2024/1788/P	75 Hillway N6 6AB	Replacement of existing fenestration with triple glazed windows and doors to front, rear and sides elevations including replacement of rooflights, introduction of new rooflight to side elevation pitched roof, addition of external solar shading blinds, replacement and enlargement of existing skylight to side annex, rendering of external elevations, timber mock-tudor detailing to front elevation, external insulation to existing roof structure, introduction of solar PV panels to the side elevation at pitched roof level, introduction of maintenance access hatch to existing rear dormer and associated works.	Patalab Architects
-------------	----------------------	---	-----------------------

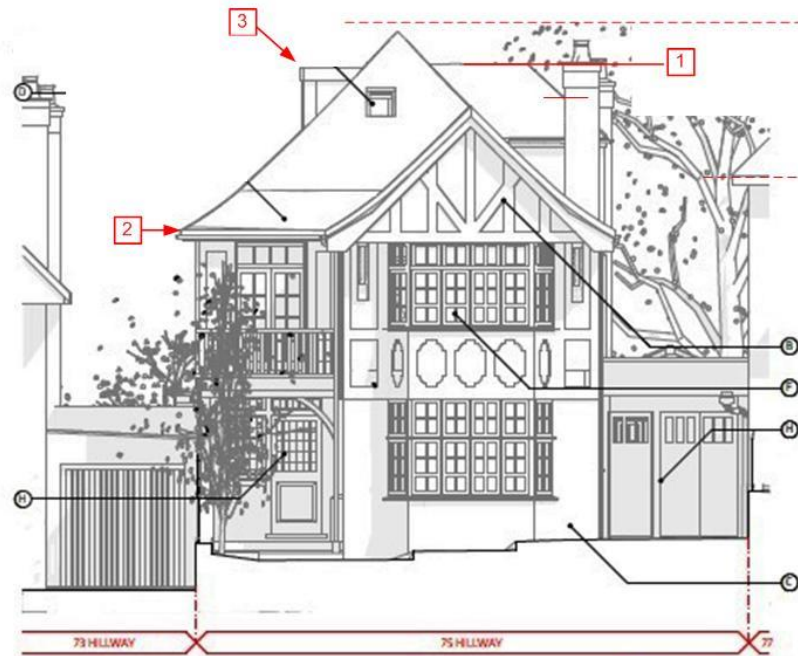
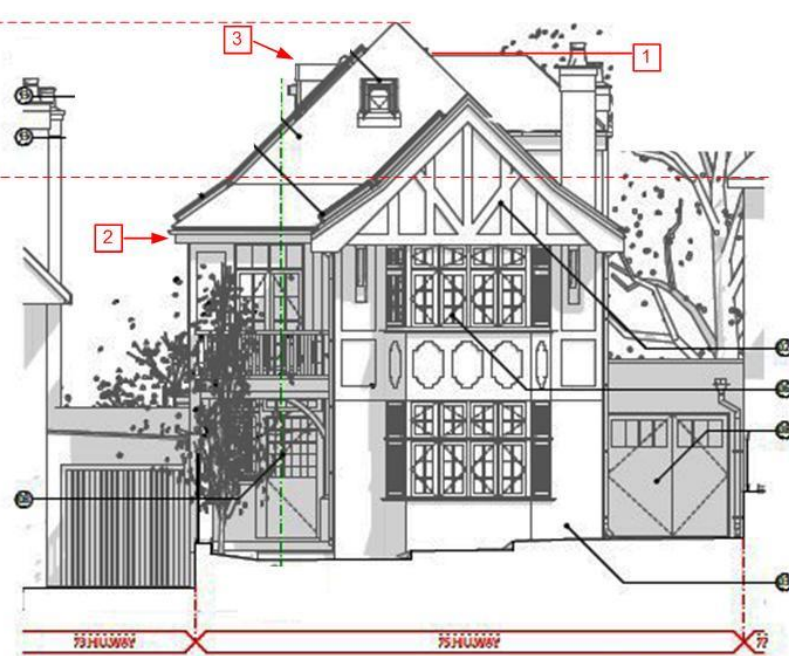
Because both the walls and roofs are having insulation applied externally and the windows can be installed to suit the new measurements the refurbishment can be done in such a way as to reduce its visual impact and generally the house will appear as before. The main indicator is the wider fascia around the roof, see (2) on attached sketch, but as the area slopes significantly, the higher roof ridge/ is hard to compare with the neighbours and thus has little impact. However, in the Avenues where the roads are more horizontal the extra height may be apparent. However, it may impact on the neighbours' views (98 Highgate West Hill is an example, 2020/1523/P, the raised ridge significantly impacted on the view from the attic of the uphill neighbour).

- (1) Roofs higher up chimney stack
- (2) Fascia board round roof taller
- (3) Window to rear appears smaller
